D
C
B
A
UNCLASSIFIED
DP2 SUBMISSION - P1338 BUILDING - PRE-FINAL SUBMISSION

DEPARTMENT OF THE NAVY
 NAVAL FACILITIES ENGINEERING COMMAND
 NAVAL FACILITIES ENGINEERING COMMAND ~ MID-ATLANTIC
 ROICC FLORENCE CAMP LEJEUNE
 JACKSONVILLE, NC
 JACKSONVILLE, NC
 P1338 II MEF SIMULATION/TRAINING CENTER
 REPLACEMENT
 PLUMBING - UNDERGROUND PLAN - AREA A

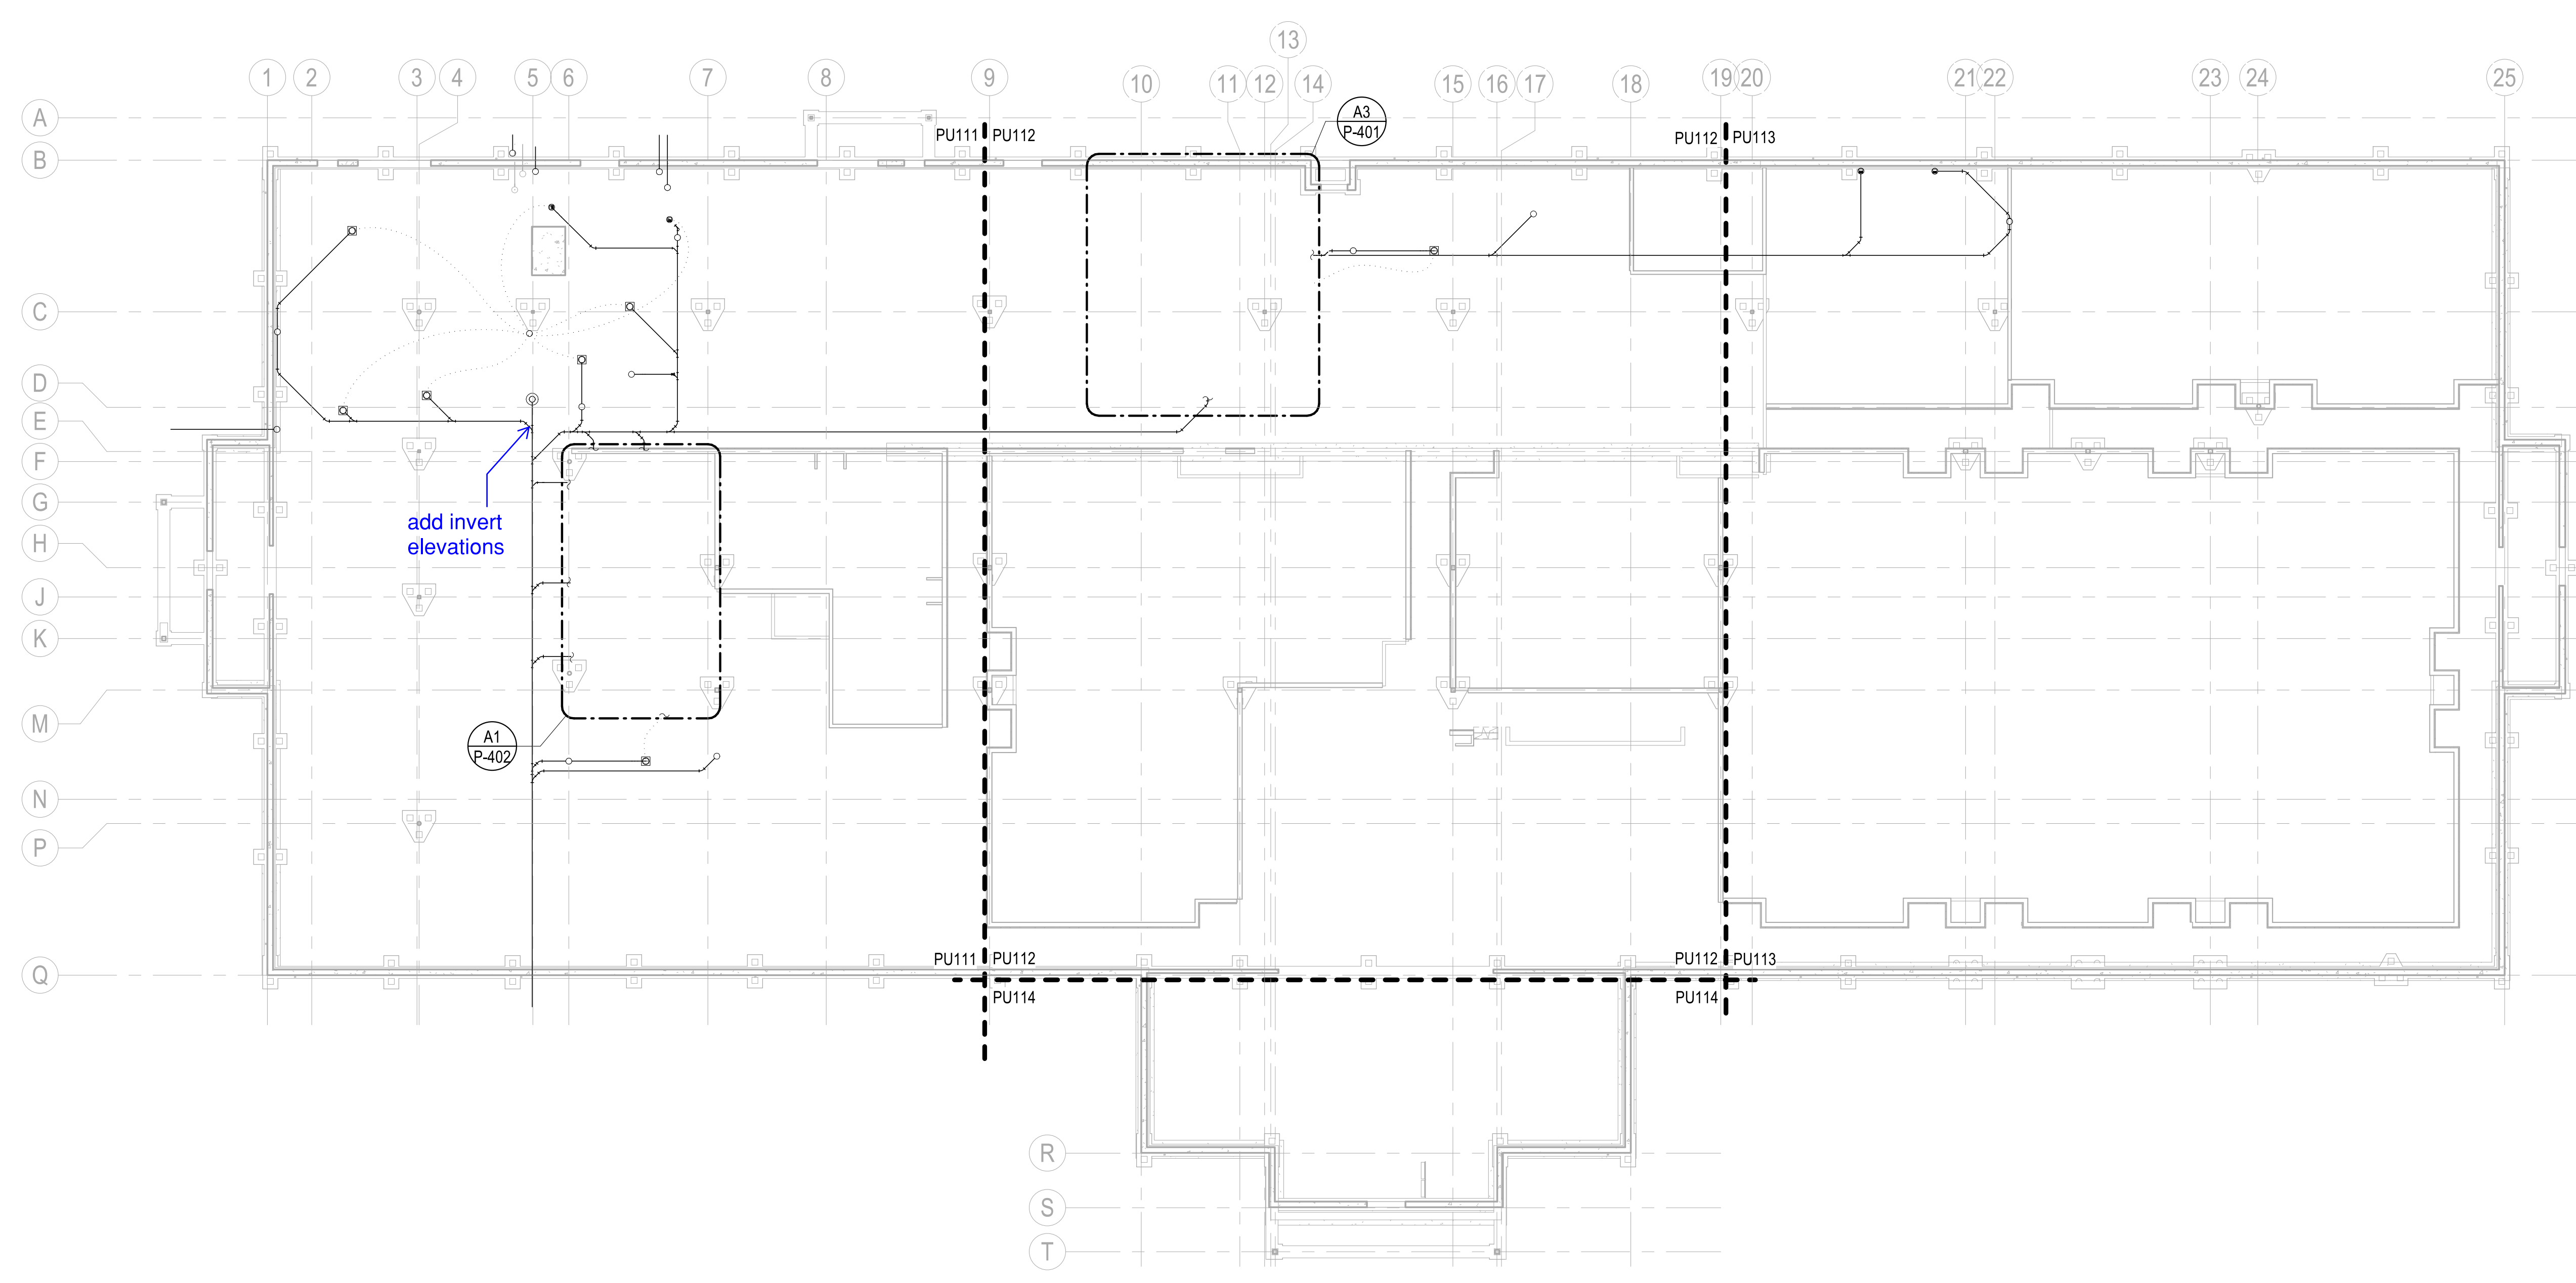
back check locations and provide access. also change standard. i think we need to eliminate one of these numbers. we did ASSE 1044 is from a lavatory, lets not use this type.

PLUMBING - FIRST FLOOR PLAN - AREA B
SCALE: 1/8" = 1'-0"

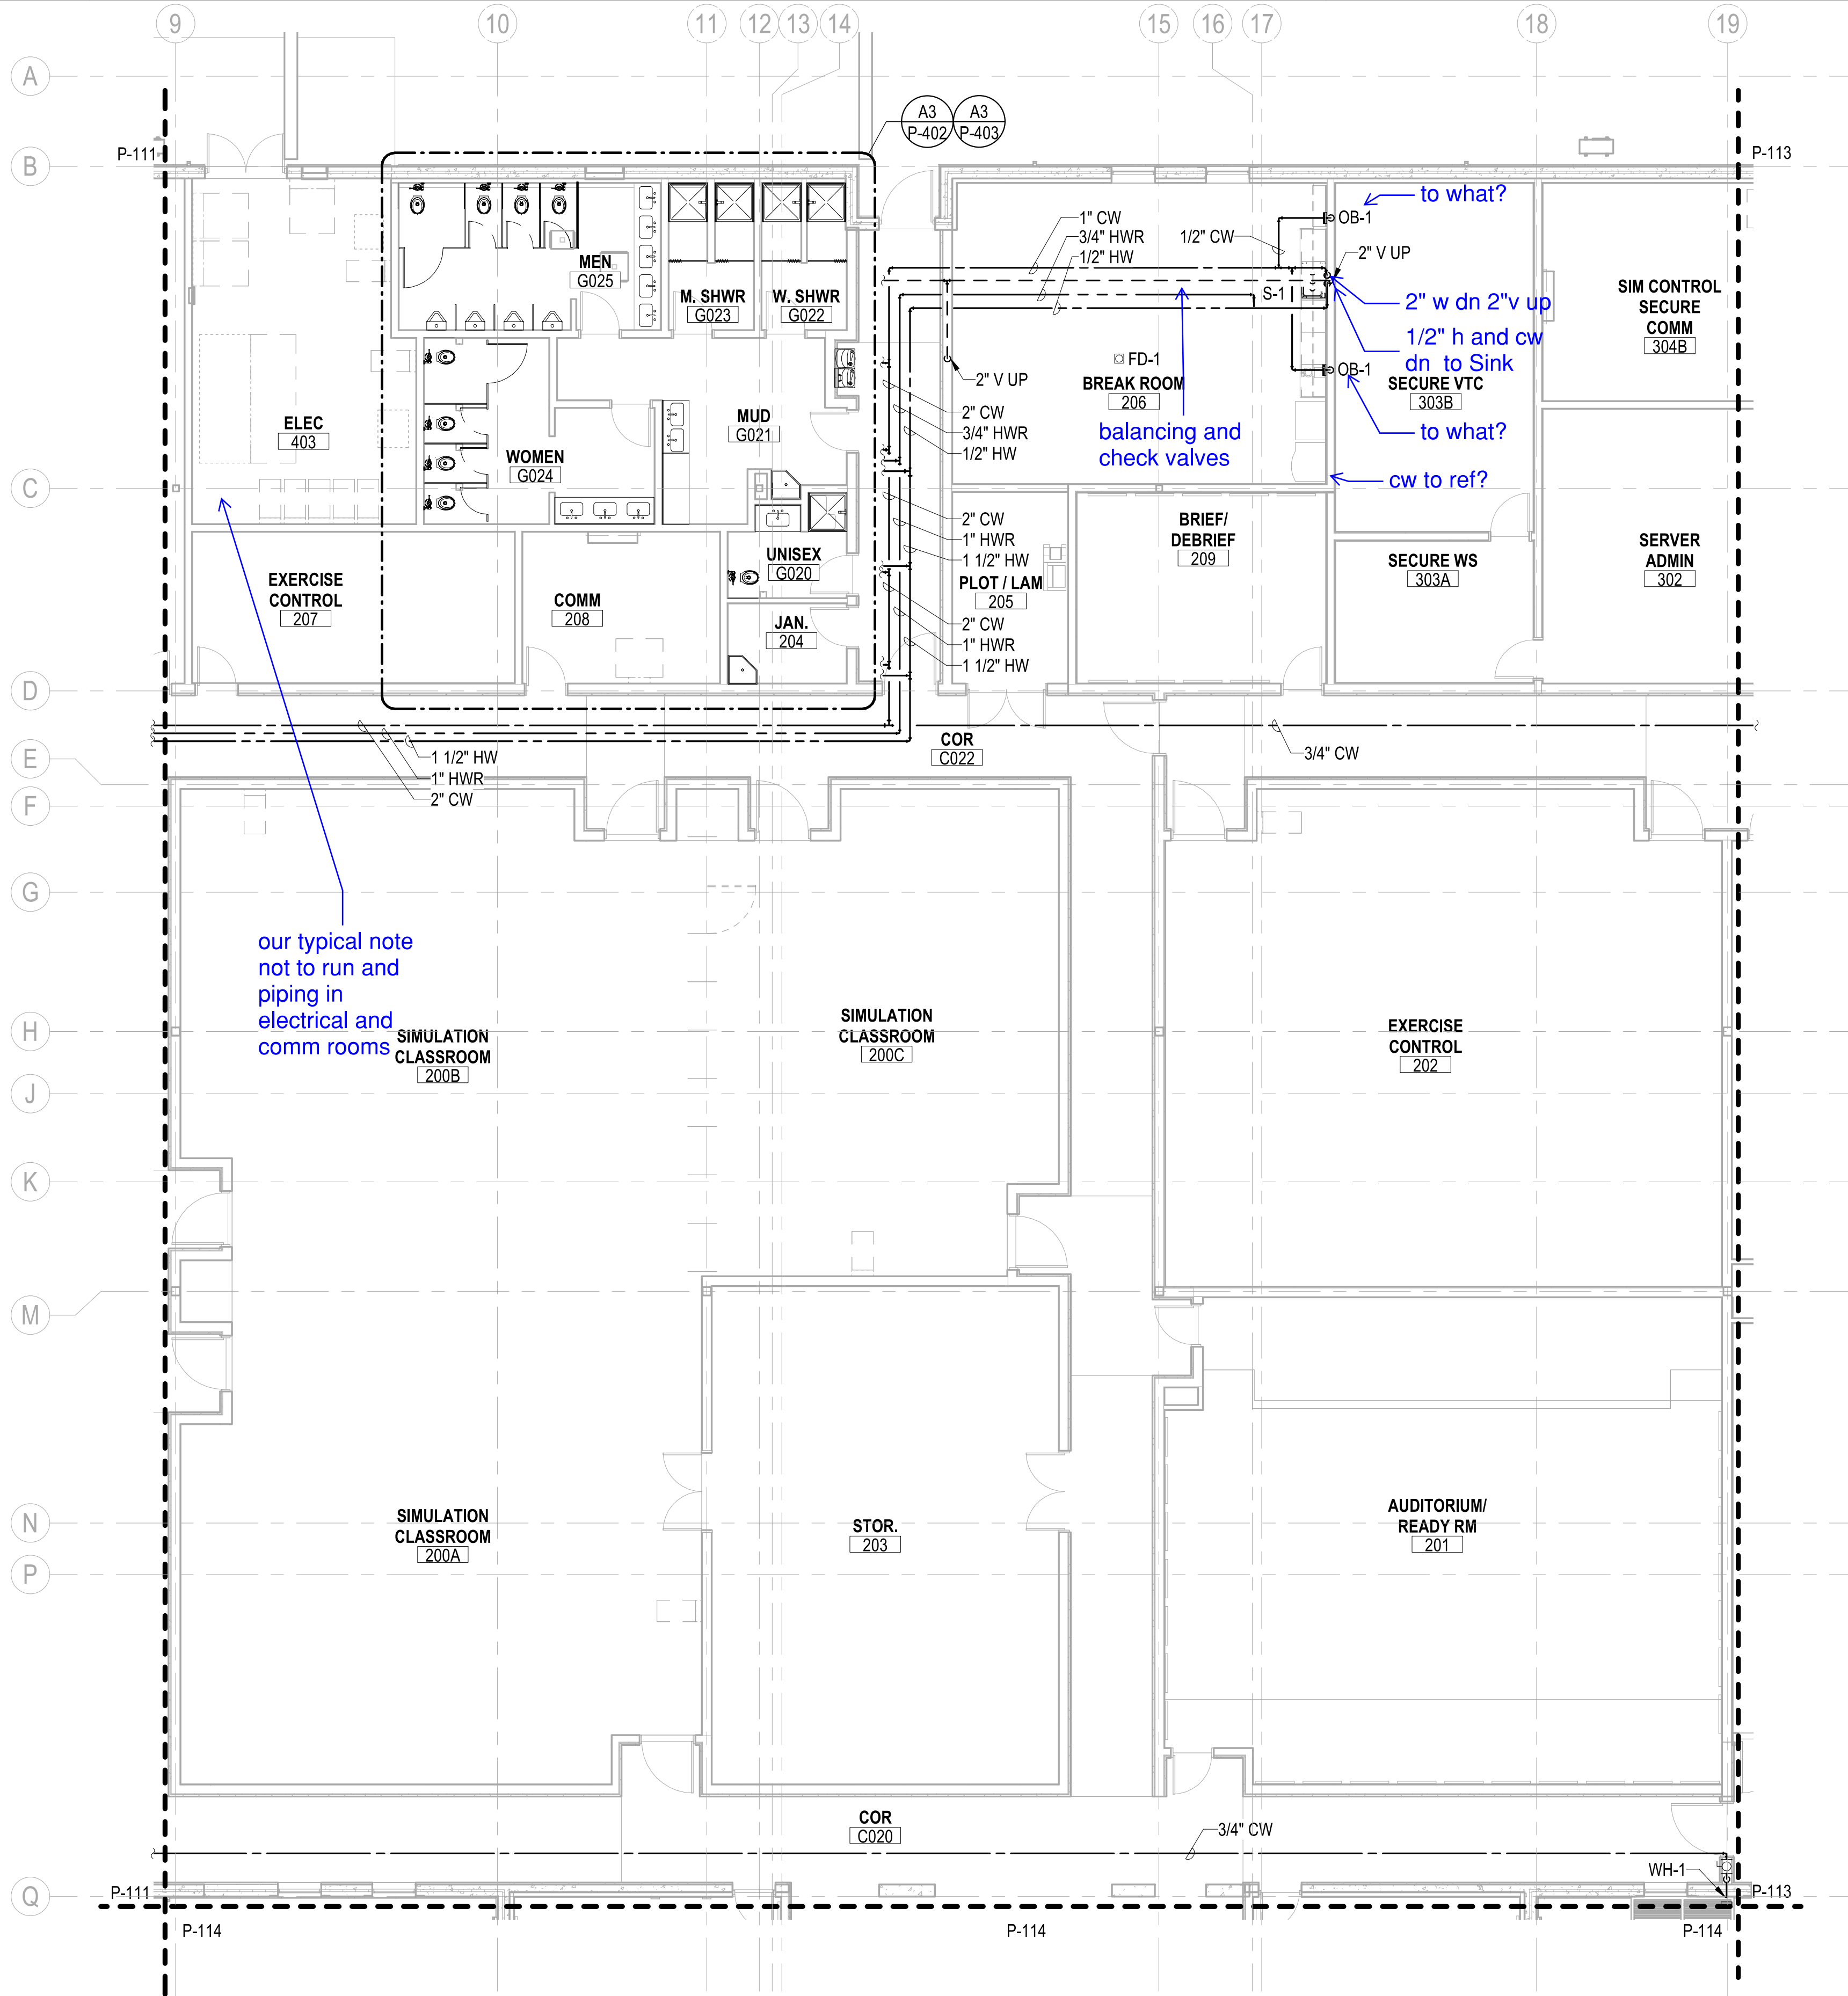
our typical note
not to run and
piping in
electrical and
comm rooms

balancing and
check valves

to what?
2" w dn 2" v up
1/2" h and cw
dn to Sink
SECURE VTC
303B
to what?
cw to ref?

PLUMBING - OVERALL - ROOF PLAN

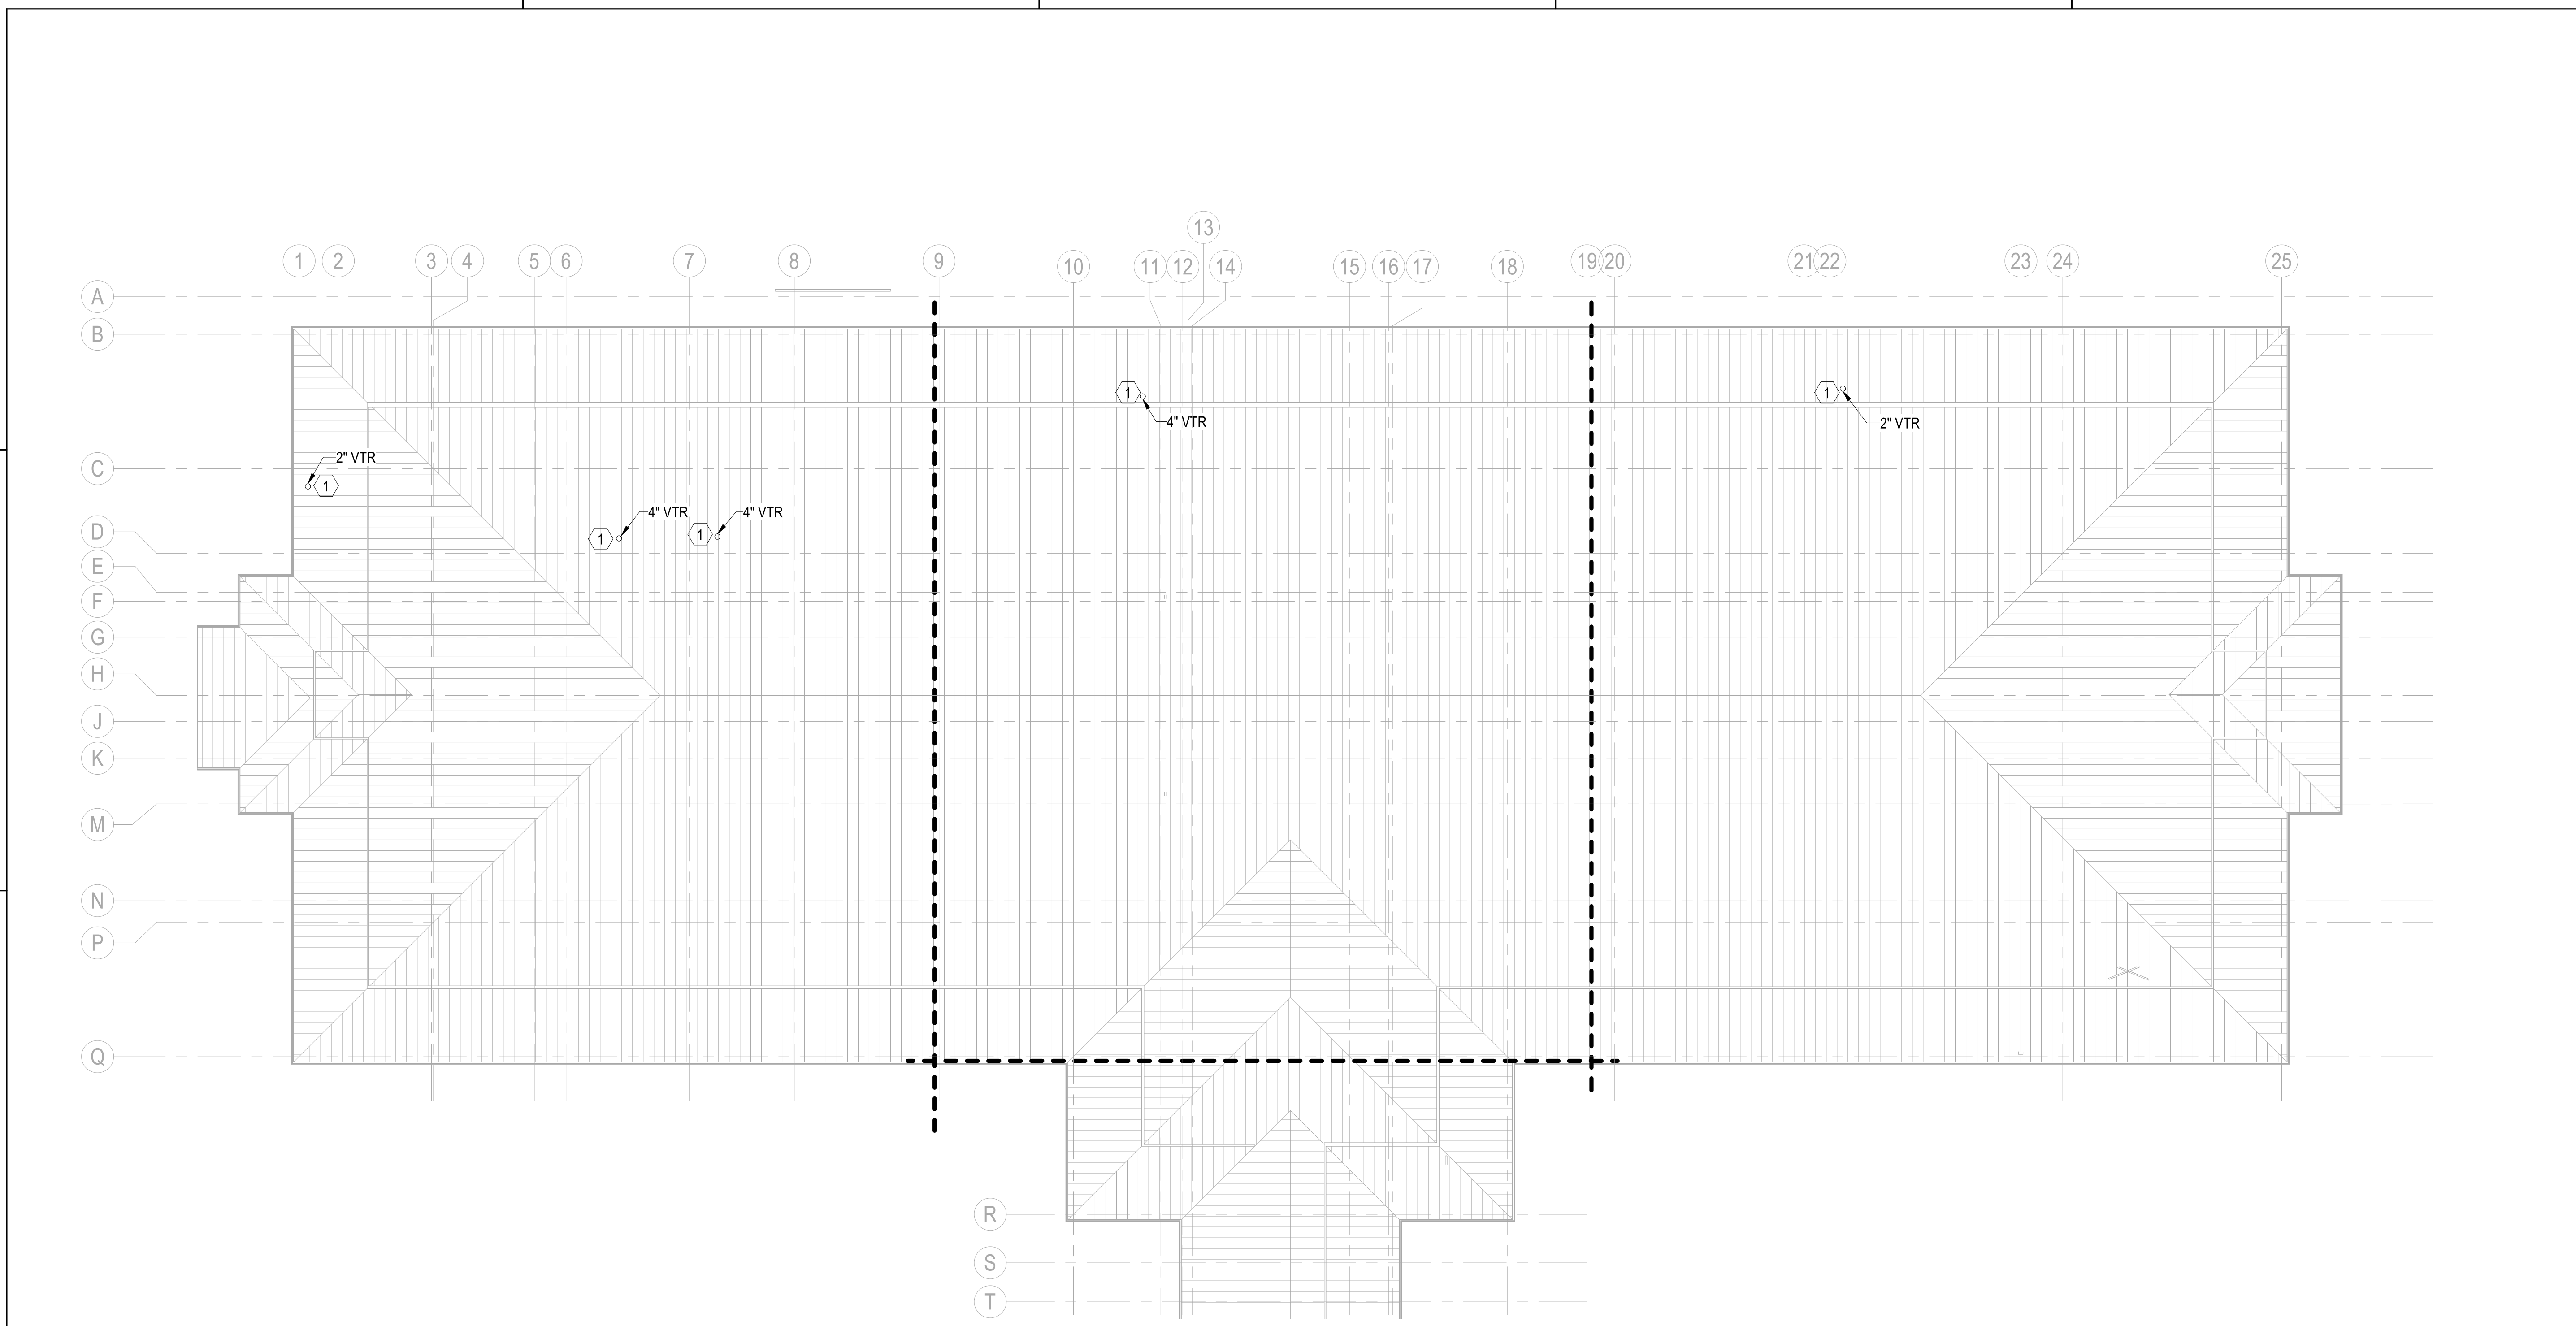
check arch for roof penetration detail
